Item ID: E4736-045 Accept ***N900040100*** Setup Start ***NS1***
 Revision ID: Stop ***NS2***
 Item Name: Fuel Filter Drain Line Assembly
 Start Date: 12/16/2015 Start Qty: 6.00 ***6*** Cust Item ID:
 Required Date: 3/1/2016 Req'd Qty: 6.00 ***6*** Customer:
 Reference:

E4736-045 FUEL FILTER DRAIN LINE ASSEMBLY

DESIGN		EAGLE COPTERS LTD	
DRAWN	BC	CALGARY, ALBERTA, CANADA	
CHECKED	BC	DRAWING NO.	REV. A
MFG. APPR.	N/A	E4736	SHEET 3 OF 5
APPROVED		TITLE	SCALE
DE APPR.		DRAIN LINE	NTS
DATE	12.11.01	COPYRIGHT © 2012 BY EAGLE COPTERS LTD THIS DOCUMENT IS PRIVATE AND CONFIDENTIAL AND IS SUPPLIED ON THE EXPRESS CONDITION THAT IT IS NOT TO BE USED FOR ANY PURPOSE OR COPIED OR COMMUNICATED TO ANY OTHER PERSON WITHOUT WRITTEN PERMISSION FROM EAGLE COPTERS LTD.

From: Harvey Siemens
Sent: March-08-16 3:52 PM
To: William Monterroza
Subject: RE: E4736 issues with the sleeve coupling

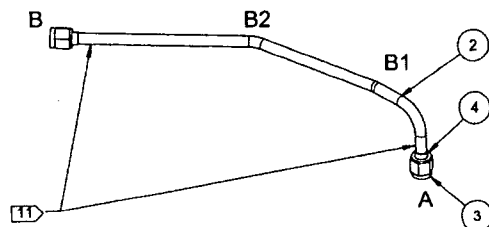
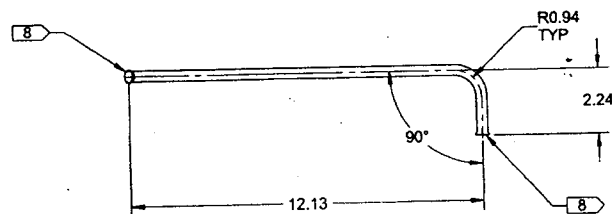
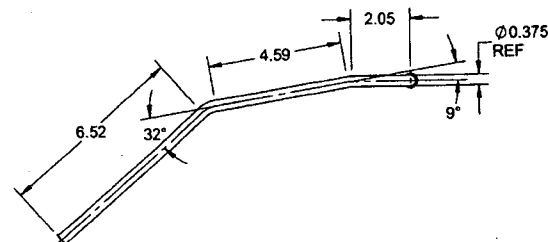
Yes, those sleeves should be the "D" version or whatever the call out is for them to be aluminum.

The drawing E4736 (attached) calls out for sleeve couplings MS20819-6J/-10J on the different configurations within the drawing.

Assembly pointed out that the -6J and -10J are stainless steel couplings, and they figure that these should really be -6D and -10D sleeve couplings, which they have stock of.

I see in the Spec for MS20189 that the Code D is inactive for new design or replacement parts, and they claim to use no code or Code J or K. Seems a bit off that even though this is stated, we would put aluminum and steel together for galvanic corrosion reasons. Do you know have any opinions on what they should use?

Change of Item 4 to MS208196D is acceptable to
Engineering
